NOTICE TO ALL BIDDERS

Re: CAMPUS SECURITY CAMERA REPLACEMENT PROJECT
RFP No 24-25-01
ADDENDUM #03

ADDENDUM #03

Document Date 08-01-24	Project Number 23-061V
	Date Last Revised 09-05-24	Reference Sheet AS3.2
		Sheet Number AD-03_AS3.2

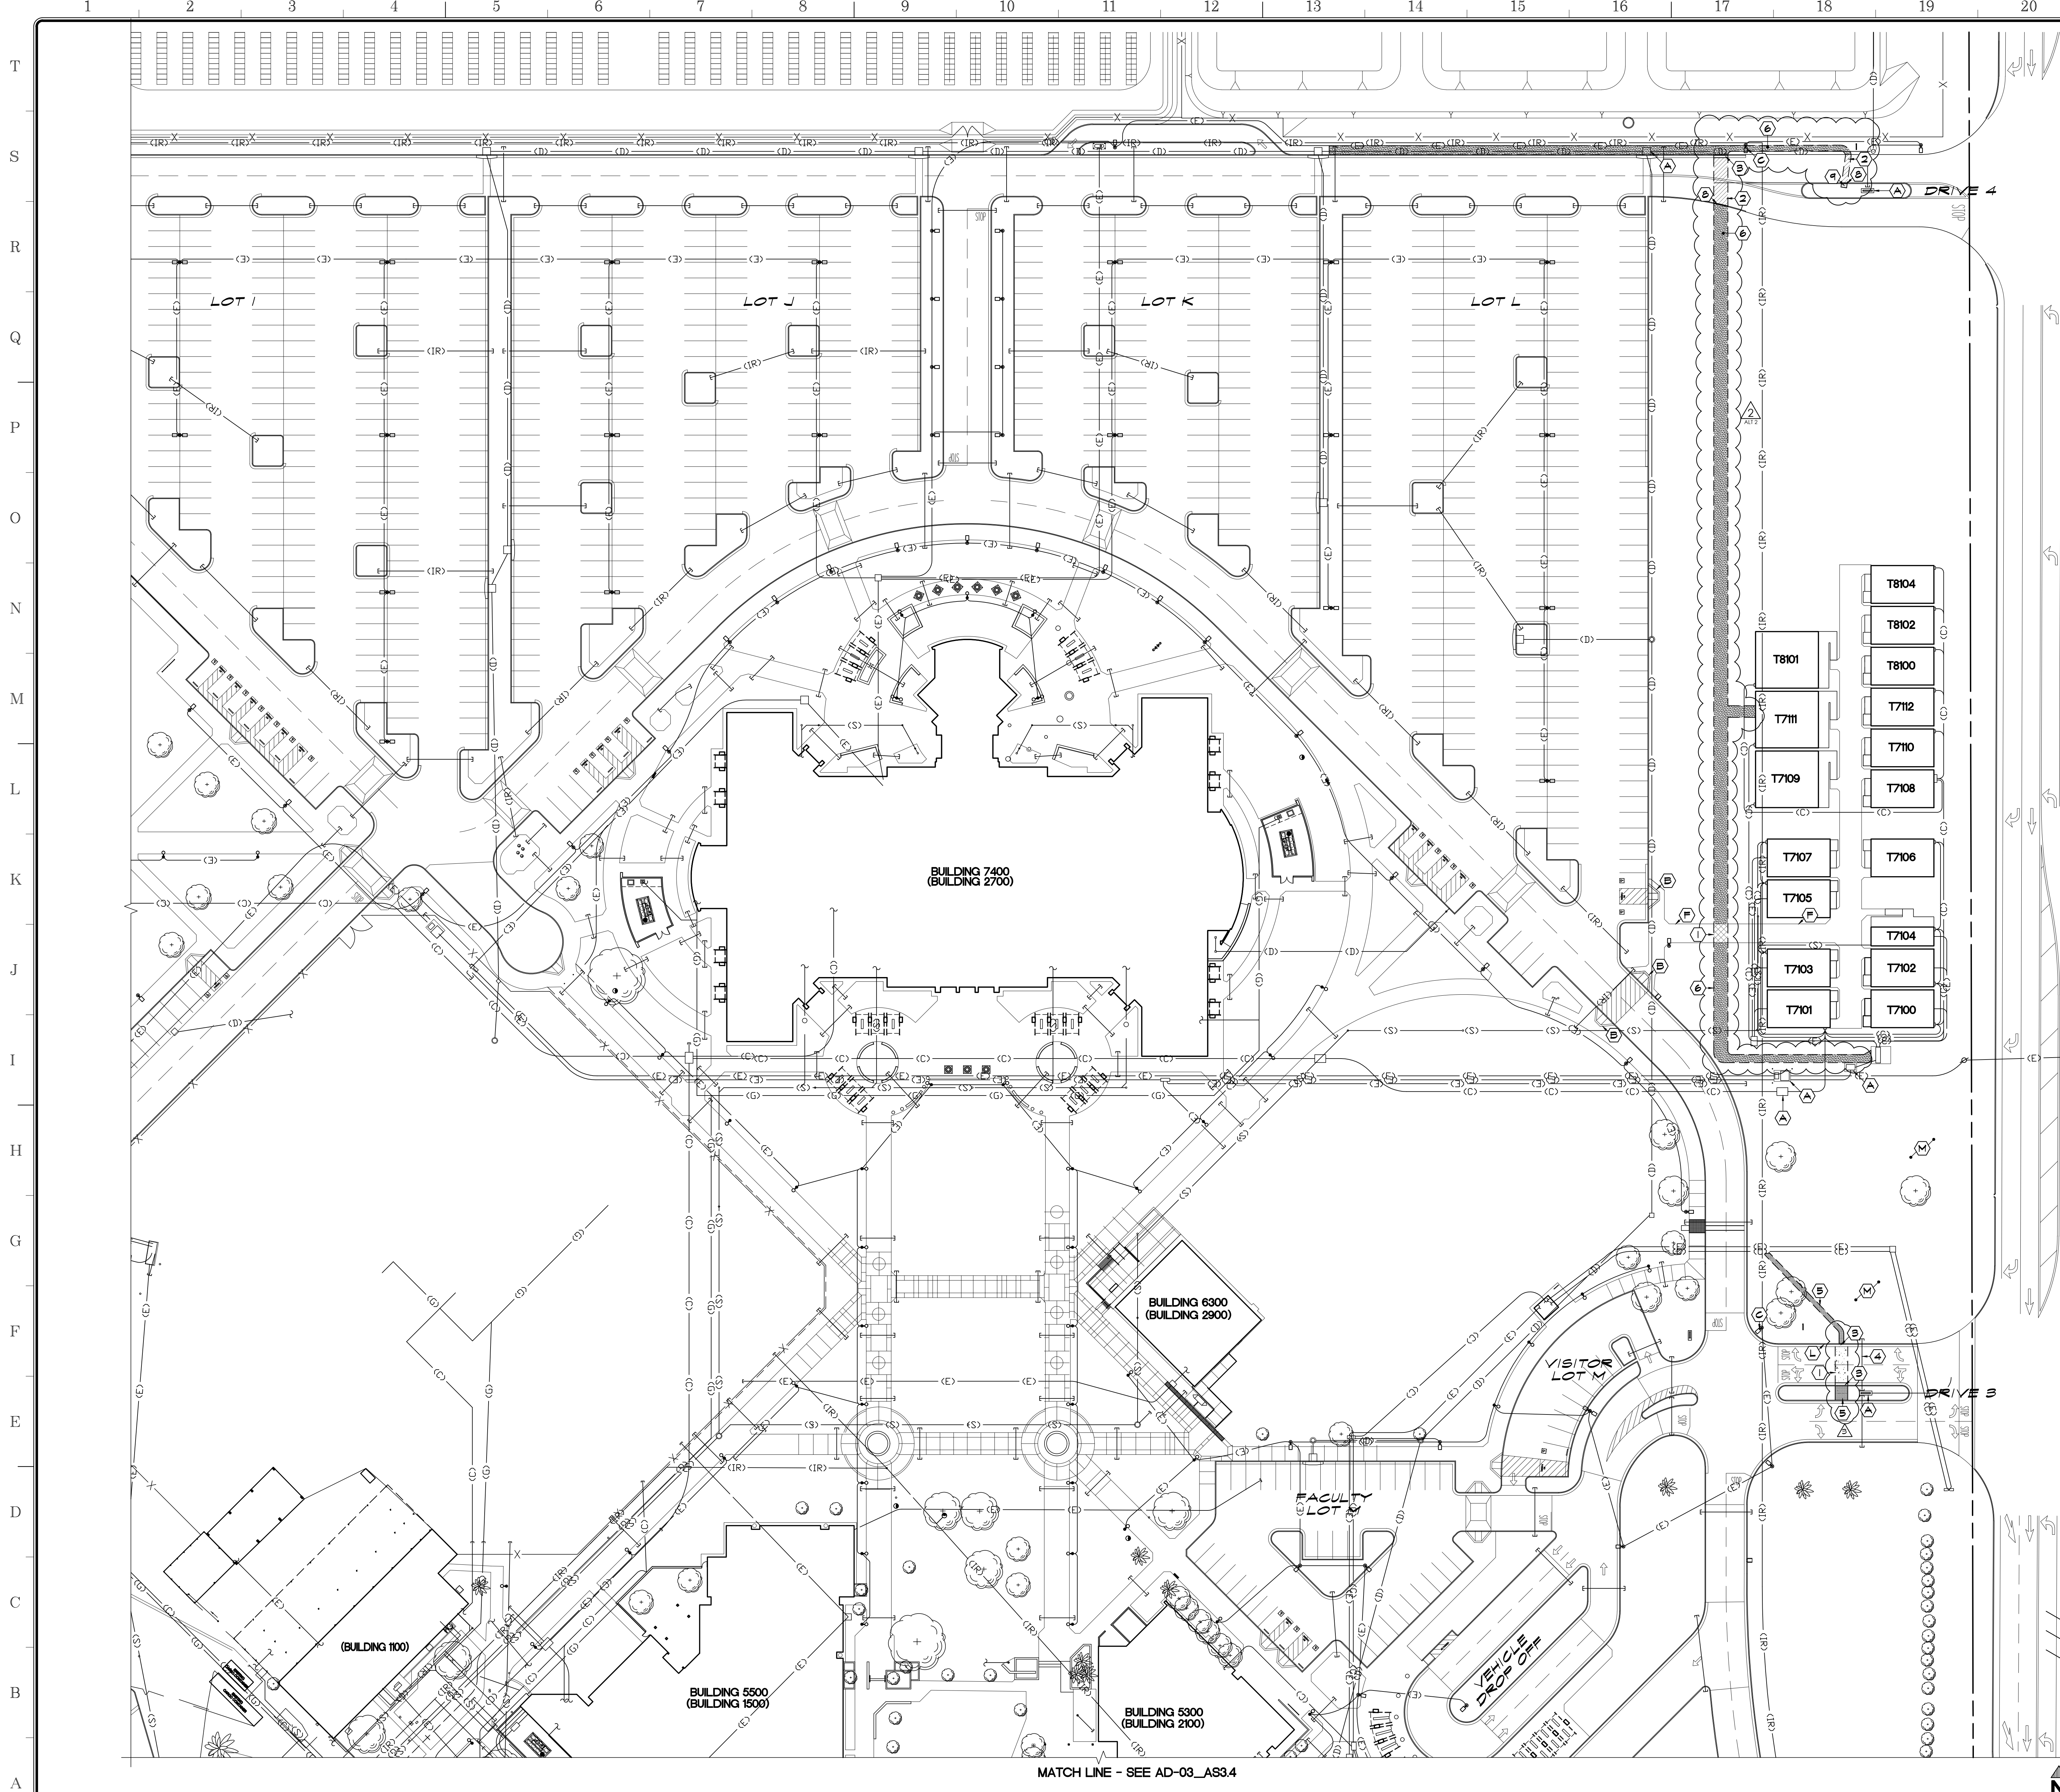
7. Sheet AS5.2 Driveway 3 indicates that the patching is asphalt and is part of Alternate Add 2. We believe this to be part of the base bid and the existing is concrete paving. So do you want concrete or asphalt for the patch back? Please advise.

- A. Driveway 3 is part of the Base Bid, it is shown as alternate Add 2 in error. Driveway 3 is concrete and needs to be patched back in concrete, the asphalt hatch was shown in error.

Document Date 07-31-24	Project Number 23-061V
	Date Last Revised 09-05-24	Reference Sheet E101
SCALE: 1" = 40'-0"		Sheet Number AD-03_E101

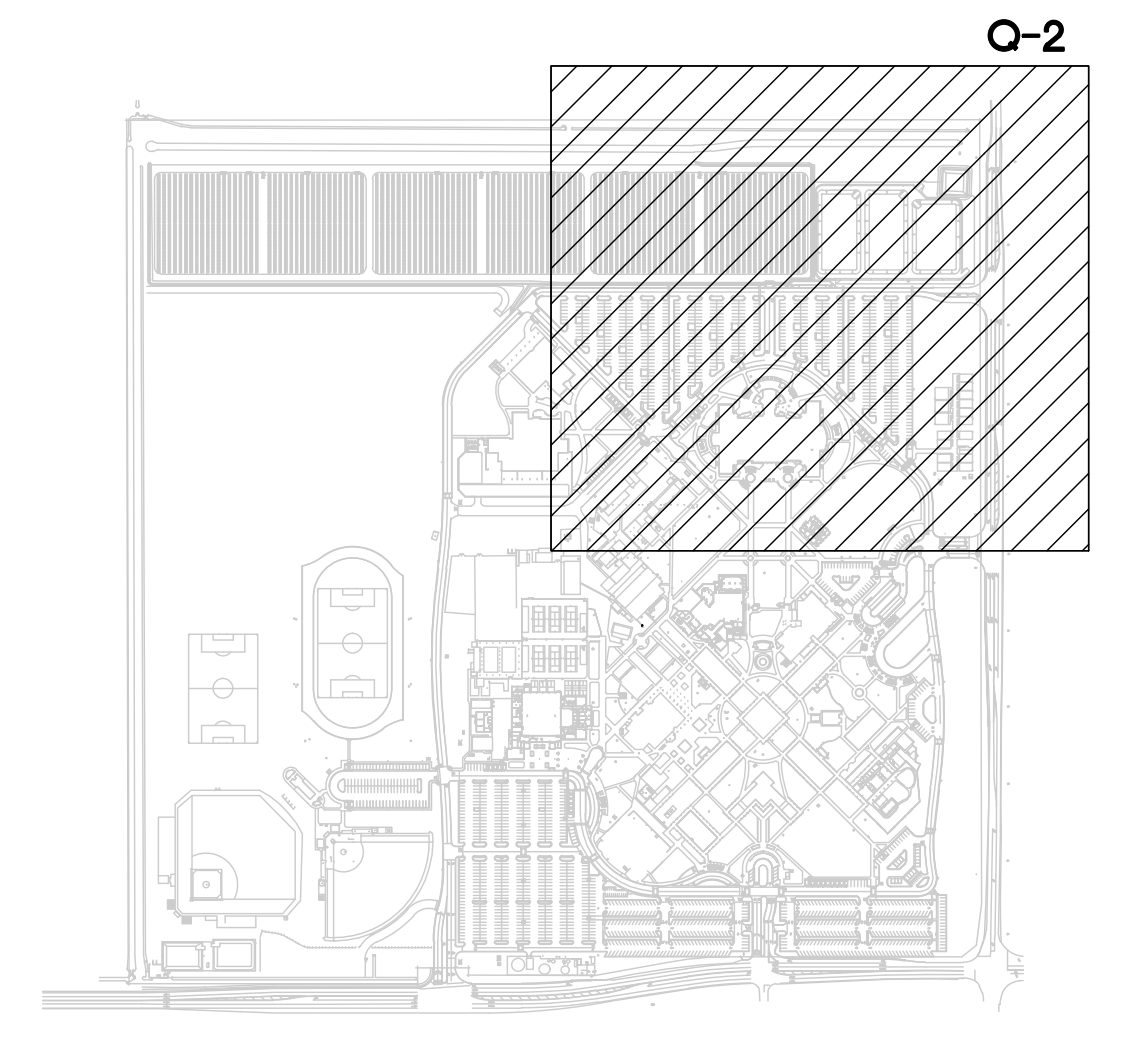
8. Per plan page E101 new underground is shown to be installed, however per plan page C MO.2 bubbled area legend 2 calls out for it to be alternate add 2. what part is to be alter nate add. Please advice.

- A. The work shown in Sheet E101 for Drive 4 is Alternate Add 2, sheet E101 has been revised to AD-01_E101, as addressed in attached document by the AOR.
